# Review of DOE Waste Package Program

Semiannual Report Covering the Period April 1985 - September 1985

**Brookhaven National Laboratory**

Prepared for U.S. Nuclear Regulatory Commission

Figure 3.2 Effects of components on as-received crystallinity. From PNL-4992.

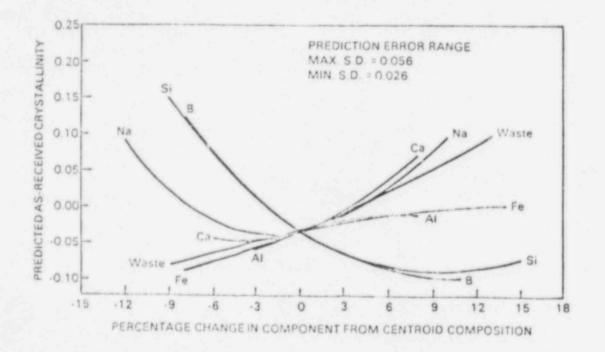
- (5) Quantitative measurement of crystallinity in a glass by comparing X-ray diffraction integrated intensity with an Al<sub>2</sub>O<sub>3</sub> impregnated specimen is an admittedly vague concept; the meaning of negative crystallinity as shown in Figure 3.2 is not clear. Consideration of crystallinity as a primary selection criteria is not very convincing because there is no definite adverse effect of crystallinity on the relevant properties of all the glasses; leach resistance, which may or may not be low in devitrified glasses, is of basic importance.

- (6) Crystallinity is included in optimization for slow cooled glasses and measured for a few other heat treatments, but the actual heat treatment in a waste canister is too complex to be represented by simple heat treatments.

Figure 3.3 Effects of components on predicted normalized Si release for Test 3 (7-day, 90°C, SA/V = 2 m<sup>-1</sup>, pH 3 buffered solution). From PNL-4992.

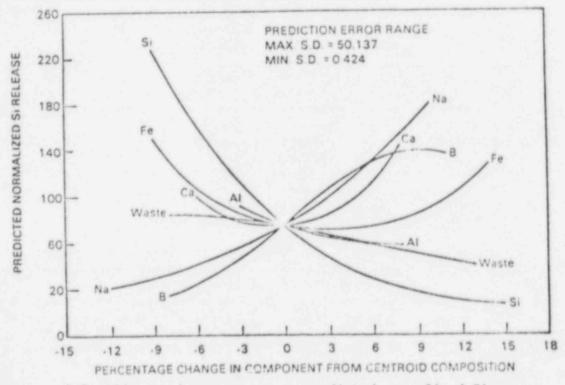
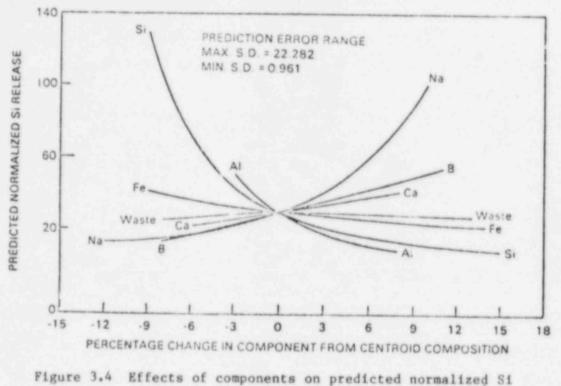
(7) 'Composite leach measure' has been defined as the sum of the logarithm of the Si concentration under four test conditions using MCC-1, MCC-2 and MCC-5 tests, and pH of leachant in an MCC-3 test. It is used as the criterion for leaching tendency of a glass composition. However, it is well known that leaching of a waste glass is too complex a phenomenon to be quantified by results from such arbitrarily defined tests.

The 'composite leach measure' should be considered only as a very crude guideline because the tests are conducted under highly simplified conditions e.g. a test duration of 3-28 days, or use of deionized water, has little resemblance to repository conditions. Furthermore, no testing is conducted in high pH or Eh conditions which can be present under certain repository performance scenarios, and all emphasis is placed on the leaching of silicon.

(8) Selection of a leach test appears to be important in determining the effect of various constituents in the glass. For example, variation of iron concentration in glass shows a minimum in silicon leach rate at the centroid composition only in one of the tests (Figure 3.3) but not in others (e.g. Figure 3.4). Thus, the optimum composition appears to depend on details of the leach test. The authors consider the flowing leach test more appropriate for repository conditions but exclude it for economic reasons.

Figure 4.1 Project schedule.

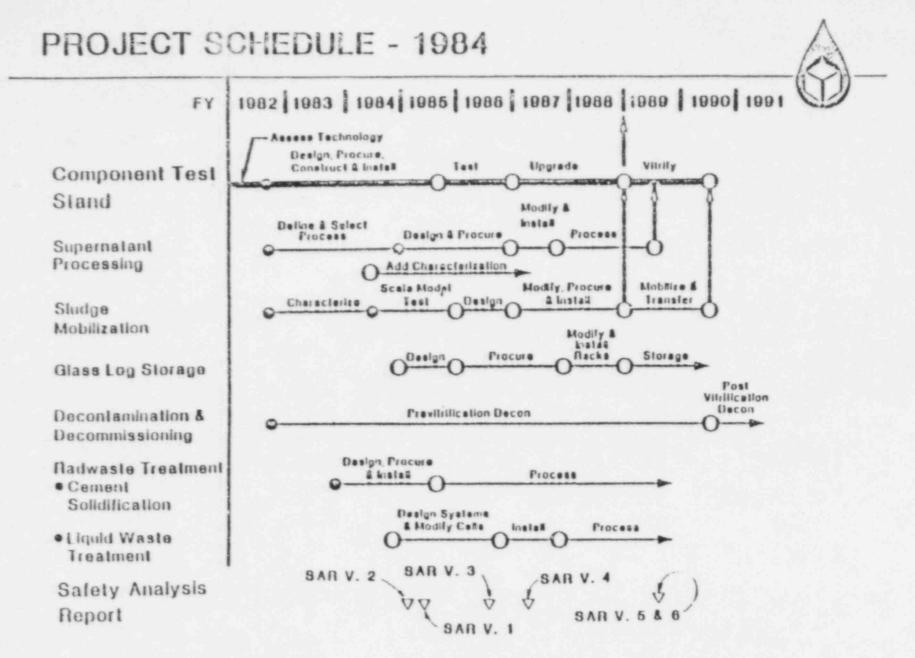
The WVDP staff feels that a staggered issuance of the SAR volumes is reasonable since different parts of the plant are scheduled for completion at different times. However, this strategy could create certain problems since it is unlikely that the safety of all subsystems of the facility can be assessed in isolation. In other words, the safety of a system cannot be accurately evaluated until those of related systems are also defined. Thus, the NRC should determine whether the sequential preparation of individual volumes of the SAR is appropriate. A possible compromise would be the issuance of a complete (if abbreviated) preliminary SAR. Timely response by NRC to this document could help limit some of the costly retrofitting of systems that the WVDP staff considers to be a possibility in the program.
